SERVICE BULLETIN

| PURPOSE: INFORMATION | ISSUE NO.: MSB-07E42-009A | DATE: 2008-08-20 | |
| | | <model> (EUR/RUSSIA) OUTLANDER</model> | <m y=""></m> |
| GROUP : BODY | | (GS45X)(CW0W) | |

QUARTER OUTER

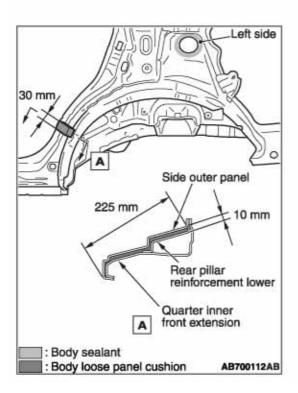
The position and the size of the body loose panel cushion that is installed when installing the rear quarter outer panel have been changed as below.

QUARTER INNER

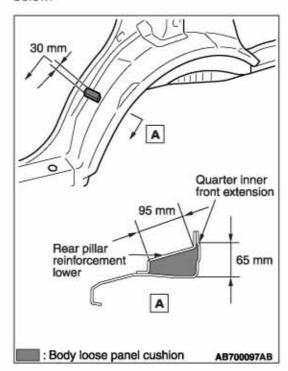
The position and the size of the body loose panel cushion that is installed when installing the rear pillar reinforcement lower have been changed as below.

UNDERCOAT APPLICATION LOCATIONS

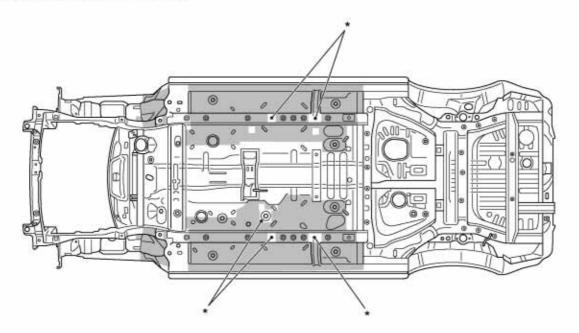
After correcting the body, restore as shown in the instructions of the figure, if necessary.

Tape the areas marked with an asterisks to protect those areas from getting any undercoating on those areas.

: Undercoat [Film thickness is at least 0.8 mm]

UNDERBODY ANTICORROSION AGENT LOCATIONS <SOME AREAS>

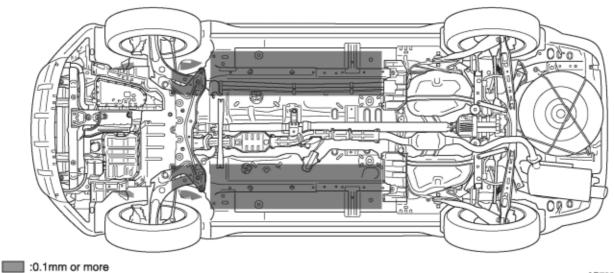
In order to provide a greater corrosion resistance, underbody corrosion prevention treatment should be performed after undercoat application. After completing body repairs, restore this underbody corrosion prevention treatment as indicated in the illustration if necessary. Recommend wax:

- Tectyl 506T, 506 or S
- Waxoyl

- Take care not to permit the anticorrosion agent to come in contact with body painting, brake parts, exhaust pipes, bearing seals for rear axle and rambler parts (such as tires and drive shaft boots).
- If anticorrosion agent gets onto the oxygen sensor, it will cause a drop in the performance of the sensor. Cover the oxygen sensor with a protective material when applying anti-corrosion agents and undercoats.
